REMARKS

Serial No.09/773,136 Examiner: Shapiro, L.

Art Unit 2673 PALM-3548.SG

FIGURE 3A

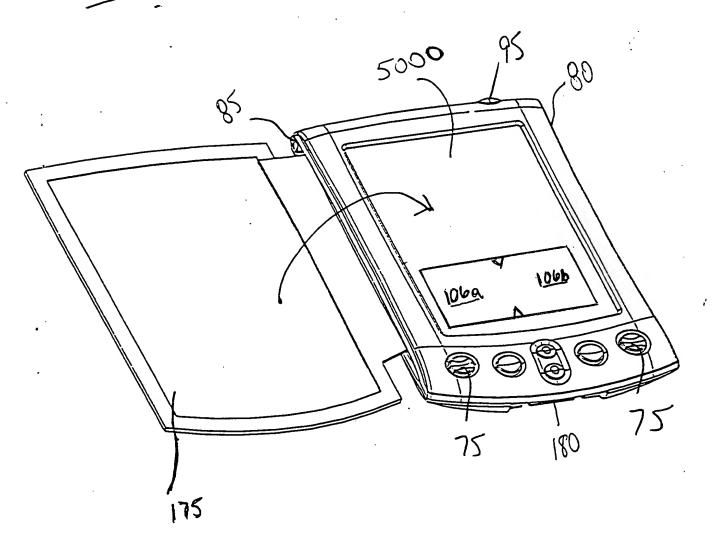
In paragraph 1 of the Office Action, the drawings were objected to under 37 CFR 1.83(a) because they fail to show references mentioned in the specification. Drawing 3A has been amended by replacement to depict "two regions 106a and 106b" which are described in page 18, lines 18 and 23. The written description was amended to address the other discrepancies between the drawings and the written description. For example, "show screen 105" was amended to "show screen 5000," "a rear angled perspective illustration 110b" was amended to "a rear angled perspective illustration 100b," "display module 5000" was amended to "display screen 5000". No new matter has been added as a result. Therefore, it is believed that this objection has been overcome.

Annotated Sheet Showing Changes
